FIRE SAFETY INSPECTION REPORT

FACTORY: Epyllion Style Limited (Extension Project)

Date: 23/04/2017

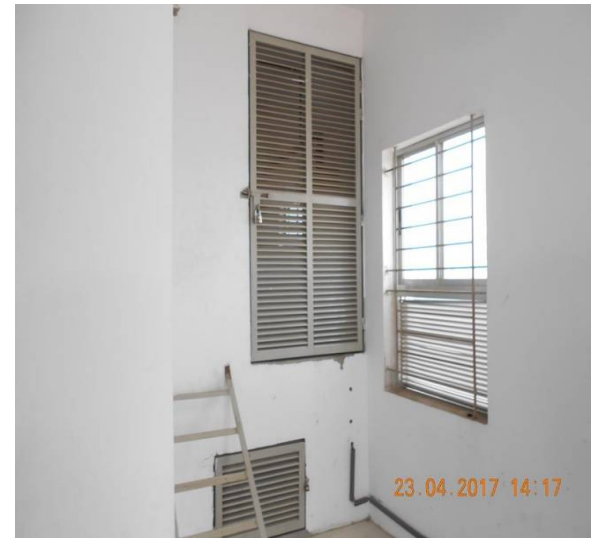
5	Fire Rated Construction	All elevator machine rooms were not separated by fire rated construction. The elevator machine rooms in Building were not provided with fire rated doors .	Separate the elevator machine rooms. by a minimum 2-hr firerated construction. Seal and/or protected all openings to maintain the required fire separations	Within 3 Months	
---	-------------------------	--	---	-----------------	--
